Southern Nuclear Operating Company
Vogtle Early Site Permit Application
Supplement To Provide Additional Seismic Analysis

Vogtle Early Site Permit Application

Supplement 4-S1*

NOTE: This enclosure contains Supplement 4-S1 pages for the following ESPA SSAR sections:

Figure 2.5.4-20a Comparison of Damping Curves - Backfill Soils

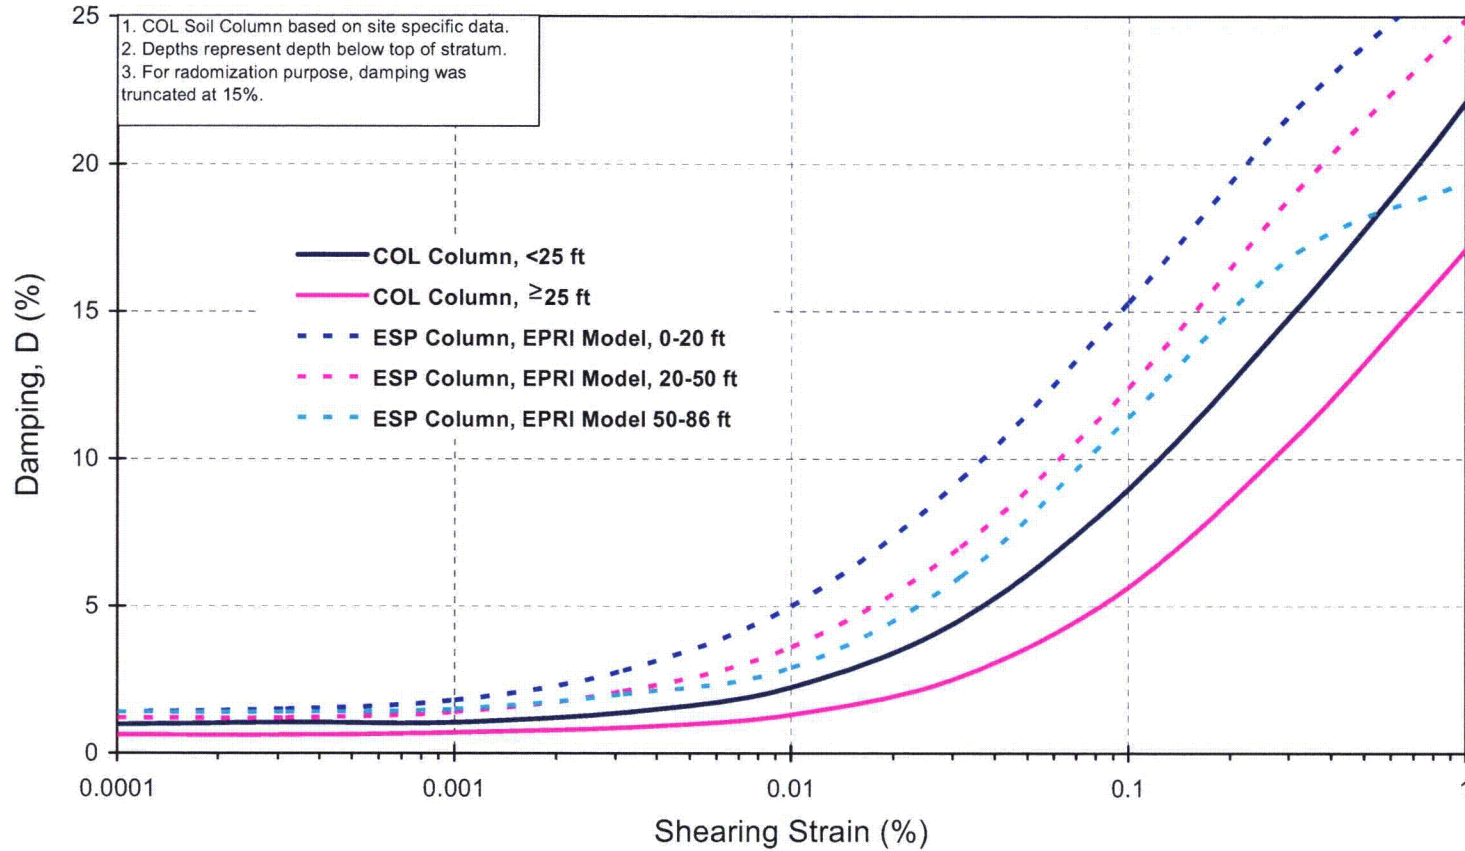
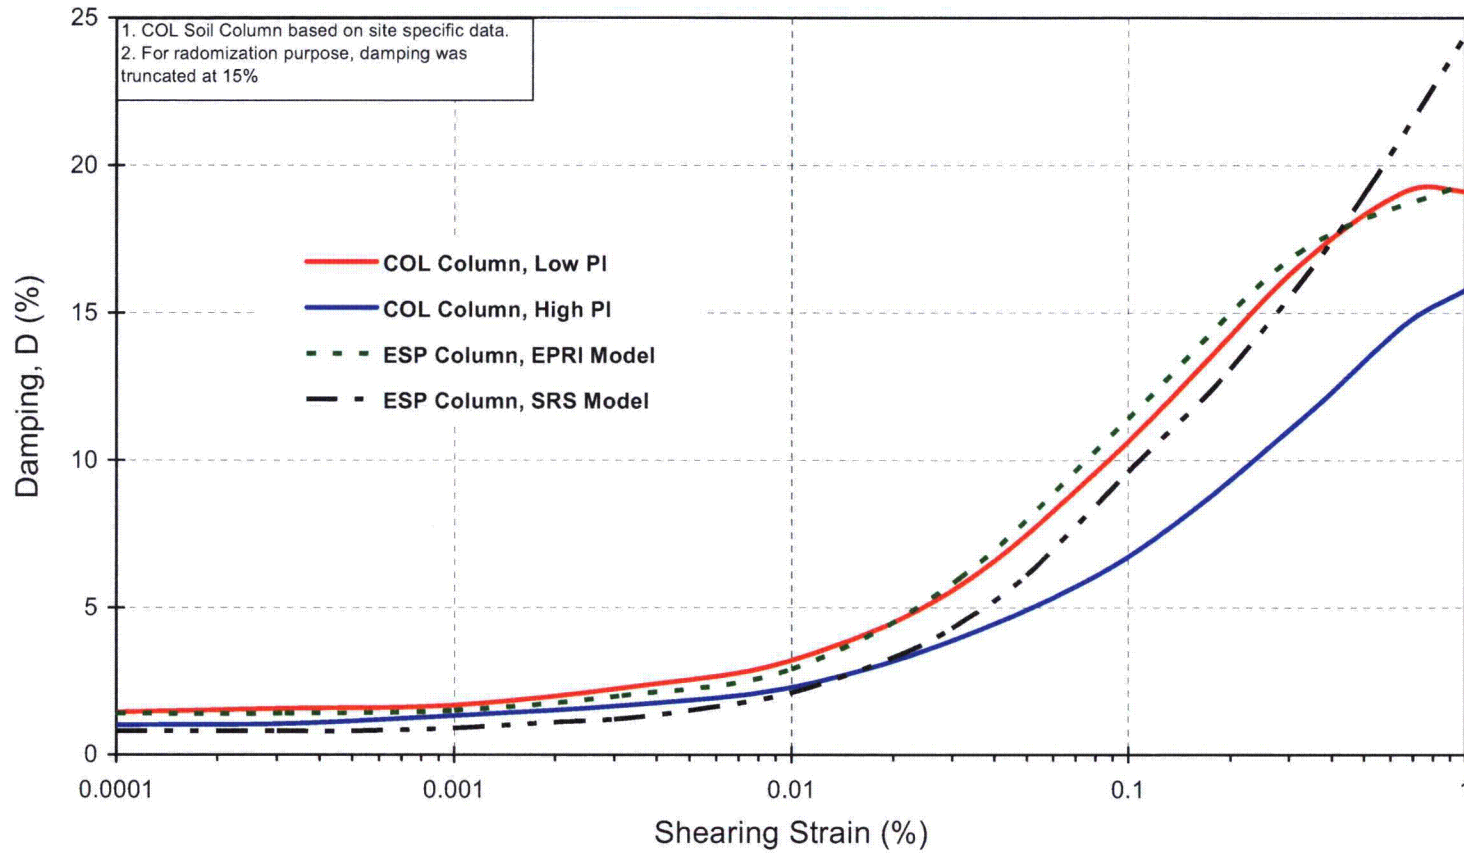
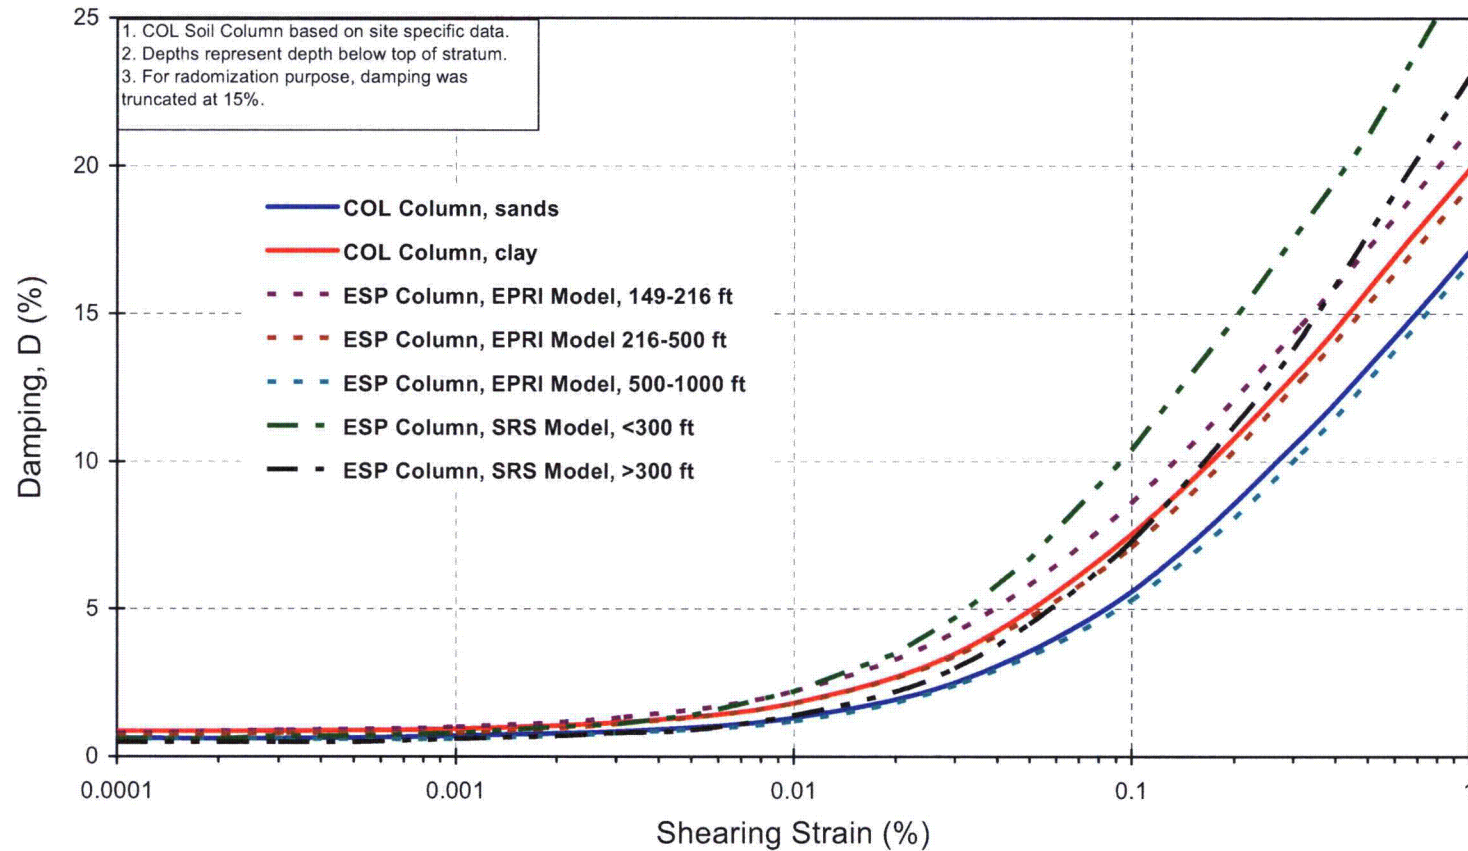
Comparisons of the soil non-linearity curves used for ESP and COL are presented in the attached Figures 2.5.4-19a through 2.5.4-20c. Figures 2.5.4-19a, 19b, and 19c illustrate the normalized shear modulus vs. shear strain curves for compacted backfill, Blue Bluff Marl, and Lower Sands, respectively. Figures 2.5.4-20a, 20b, and 20c illustrate the soil damping vs. shear strain curves for the same strata. The figures include both the site specific curves developed during the COL investigation and the EPRI and SRS model curves assigned during the ESP investigation. The COL site specific data for the Lower Sands includes non-linearity curves for both sand and clay materials in this stratum. Generally the figures suggest that the subsurface soils behave more linearly (provides a smaller reduction in shear modulus and less damping) than the models used for the ESP investigation.
